INITIAL FIRE SAFETY INSPECTION REPORT

Factory name: Texeurop (BD) Ltd. (Extension)

RSC ID: 24535

Date: 22 Nov 2023

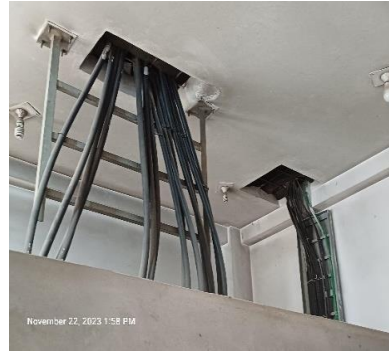
SI No.	Category	Findings	Required Action	Remediation Time Frame
1	Fire Rated Construction	The exit stairs are not separated from work areas and other spaces on each floor by fire rated construction. (Building No. 06 (New Building) & Substation Building)	Provide minimum 1-hr rated doors for buildings with 3 or fewer stories and 1.5-hr fire rated doors for buildings that are 4 or more stories. Seal all unprotected openings to separate the exit stairs from work areas and other building spaces on all floor levels. Ensure that the fire doors are self-closing and positive latching and that they are provided with fire exit (panic) hardware where serving production floors. If fire doors are required to be held open for functional reasons, provide automatic closing devices tied to the fire alarm system. Once fire doors are installed, every door in a stair enclosure serving more than 5 stories shall be provided with re-entry unless it meets.	Within 3 months

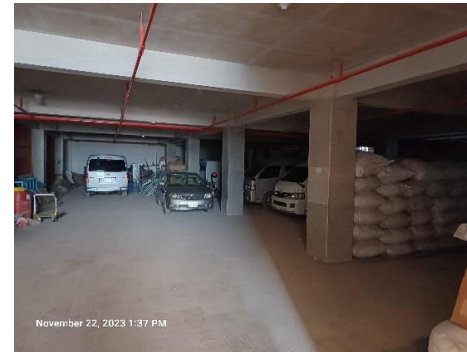
4	Fire Rated Construction	Rooms used for combustible storage are not separated by fire rated construction on the basement, ground, 1st, 2nd, 3rd, and 4th floors. (Building No. 06 (New Building))	Separate the dedicated storage rooms by minimum 1-hr fire-rated construction. Provide 0.75 hr. fire rated door and seal all penetrations and openings by 0.75 hr. (45 Minutes) fire rated fire rated barrier construction. Where separate storage rooms are not feasible, provide defined storage areas and limit the storage arrangement as follows: - Maximum height of 2.45m (8ft.) , maximum area of 23m² (250 ft²) and 3m (10ft.) clear distance from adjacent another unenclosed combustible storage. - If the building/floor is sprinkler protected: maximum height of 3.66m (12ft.) and maximum area of 93m² (1000 ft²).	Within 2 months
---	-------------------------	--	--	-----------------

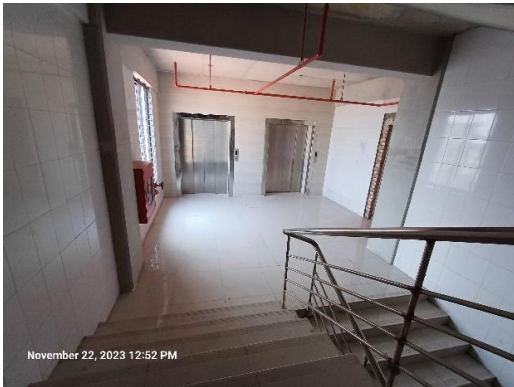
5	Fire Rated Construction	Elevator shafts are directly open into exit stair enclosure-1. (Building No. 06 (New Building))	Modify the elevator shaft as per RSC Technical Guideline (Standard) V1-6.14.3. An exit stairway shall not be built around a lift shaft unless both of them are located in a smoke proof enclosure and made of a material with fire resistance rating required for the type of construction of smoke proof enclosure. So, rearrange the facility to provide separate enclosure for lifts. If not possible anyway then provide a minimum 2-hr fire- rated elevator shaft with listed fire rated lift landing door to separate from each floor level.)	Within 3 months
---	-------------------------	--	---	-----------------
